## Eight Discipline Report (8D Report)

To:	8D report No.:
From: : <b>Chicony Power Technology</b>	RMA claim No.: <b>N/A</b>
CC :	Chicony Power P/N: <b>A180AP01Q-FW01</b>
	Customer P/N: <b>PK37A019500</b>
Submit date: <b>2023/8/18</b>	Product description: <b>180W PD</b>
Receive date: <b>2023/7/20</b>	Defect D/C or Lot No.:
<b>Subject : 客戶通知有一台 adapter 無輸出也無溝通 (MOSFET)</b>	
<b>D1.) 問題解決成員: Use Team Approach</b>	
主持者 (Team Leader) : <b>Cf Liu</b> 內部成員 (Internal Team Members): <div style="text-align: center; margin-top: 10px;"> <b>CQS: Jack Wang</b>  <b>QE: Kitty Zhang</b>  <b>MFG: Xiaohui Du</b>  <b>PE: Yong Liu</b>  <b>Sales: Gordon Wang</b>  <b>RD: Chris Wu</b> </div> 外部成員 (External Team Member):	
<b>D2.) 問題說明: Problem Description:</b>	
(Note: Use <b>who, what, when, where, why, how, how many</b> to specify the Customer's problem.)	
<b>2023/7/20 客戶告知:</b> <p style="margin-top: 10px;">我們這邊有一顆 Adapter 壞掉了，不論怎麼插拔都沒有辦法回覆，連溝通都沒有了</p> <p>Adapter 就插著充電，突然就沒有充電了</p> <p>產品序號: <a href="https://fr.mw/FRANCNCH71312100BY">https://fr.mw/FRANCNCH71312100BY</a> 檢視樣機外觀並無異常。</p>

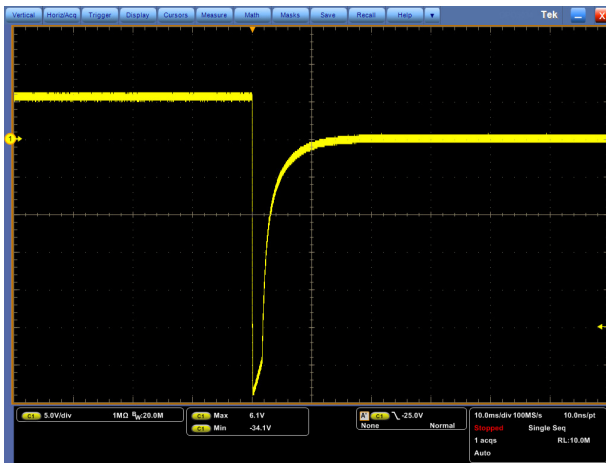
3. 打開外殼，觀察元件面跟鉚錫面，元件面看起來無異常，鉚錫面挖膠後明顯發現U1, S1, S3 損壞

### PD 3.1

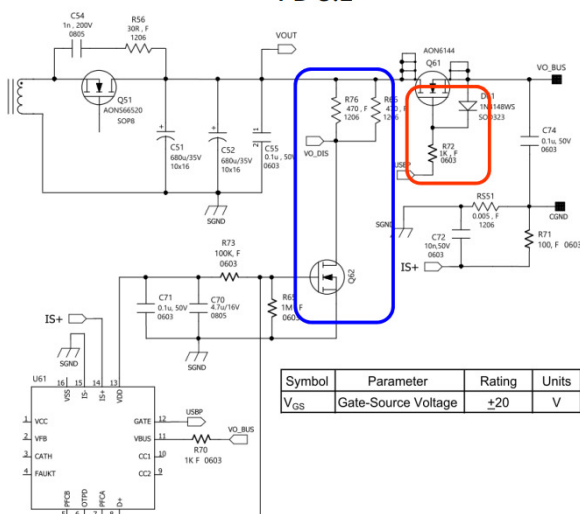
4. 問題復現: Adapter開機到 36V輸出後, 在DC cable unplug時, 量測 Q61 (Blocking MOS )  
Vgs=-34.1V, 超出零件規格 (規格為-20V), 導致 S1 & S3 short through , 造成 PSU 損壞

5. 解決對策: 180W PD 輸出電壓規格最大為36V, 當DC cable unplug 時, 瞬間逆向電壓較大, 故須使用二極體及放小 Rg 電阻, 讓 Q61 Vgs 快速放電

1. R73 1M→1N4148WS
2. R72=30K→10K
